UNITED STATES PATENT AND TRADEMARK OFFICE

APPLICATION NO.	FILING DATE	FIRST NAMED INVENTOR	ATTORNEY DOCKET NO.	CONFIRMATION NO.
10/550,322	07/10/2006	Luis Santos Lopez	U 015944-3	1762
140	7590	06/05/2007		
LADAS & PARRY 26 WEST 61ST STREET NEW YORK, NY 10023			EXAMINER MAYO III, WILLIAM H	
			ART UNIT 2831	PAPER NUMBER
			MAIL DATE 06/05/2007	DELIVERY MODE PAPER

Office Action Summary

FIGURE 1

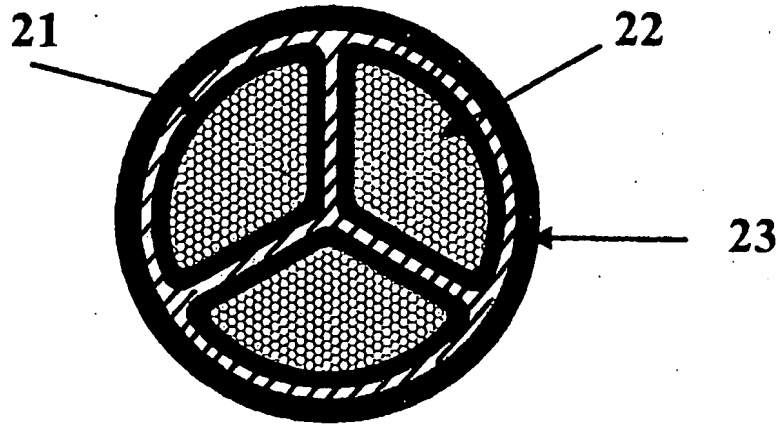
1. The drawings were received on February 12, 2007. These drawings are not approved because Figure 1 lacks the proper cross-hatching which indicates the type of materials, which may be in an invention. Specifically, the cross hatching to indicate the conductive and insulative materials is improper. The applicant should refer to MPEP Section 608.02 for the proper cross-hatching of materials. Correction is required.

NOT
APPROVED
WJH/MTJ
8/27/07
